UNITED STATES PATENT AND TRADEMARK OFFICE

APPLICATION NO.	FILING DATE	FIRST NAMED INVENTOR	ATTORNEY DOCKET NO.	CONFIRMATION NO.
10/736,656	12/16/2003	Brent R. Jones	D/A3075Q	6302

Office Action Summary

DETAILED ACTION

FIG. 3

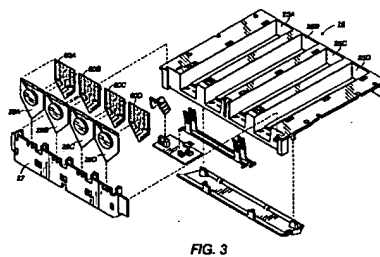
- {claim 1} A solid ink melt assembly for use in a phase change printer (figure 3); a drip plate with first and second sides (figure 3, reference 60A-D); a lower portion of the plate is shaped to form a drip point (figure 4, reference 52); a heater mounted to the first side of the plate and in direct contact with the plate without any insulating layer therebetween (figure 3, reference 29A-D); wherein the second side of the drip plate is directly exposed to ink sticks for melting (figure 3)

- {claim 7} wherein at least one formed flange extends outward from the second side along at least one side edge (column 7, lines 10-15)
- {claim 12} wherein each assembly is mounted to an ink loader with an individual adapter (figure 3, reference 25A-D)

- {claim 13} a retaining clip to prevent large scale separation of heater elements from the drip plate (figure 3, reference 27)
- {claim 14} An ink loader for use in a phase change printer (figure 3); at least one channel having an entry end and an exit end (figure 3, reference 25A-D); a melt assembly (figure 3); a metallic drip plate with first and second sides, wherein the drip plate is formed so as not to allow fluid to pass through from the second side to the first side (figure 3, reference 60A-D); a heater mounted directly to the first side without any insulating layer therebetween (figure 3, reference 29A-D)
